UNITED STATES PATENT AND TRADEMARK OFFICE

APPLICATION NO.	FILING DATE	FIRST NAMED INVENTOR	ATTORNEY DOCKET NO.	CONFIRMATION NO.
09/805,529	03/13/2001	Akira Shiokawa	NAK1-BO21	2114

Office Action Summary

DETAILED ACTION

FIG. 25

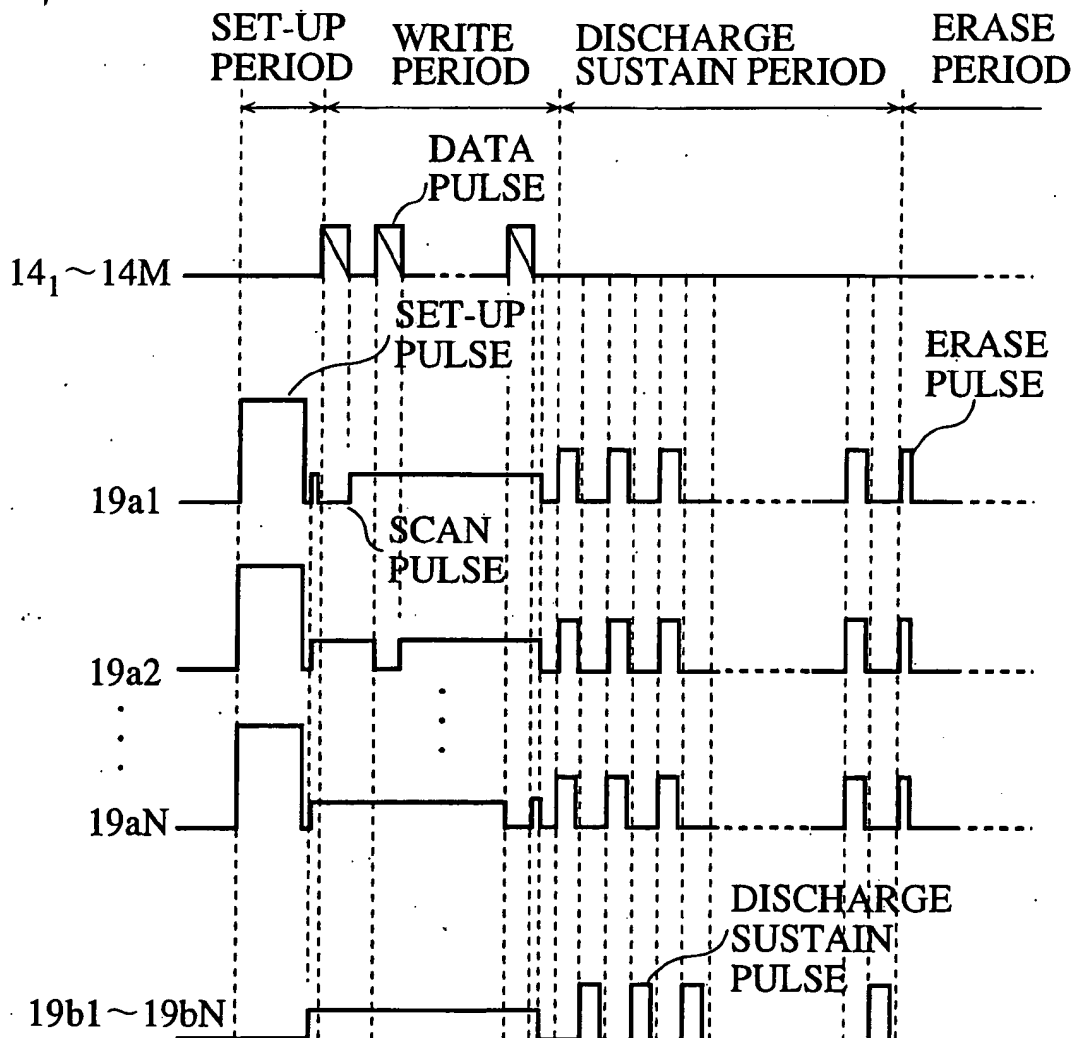
Approved by
JHN
04/24/04

PRIOR ART
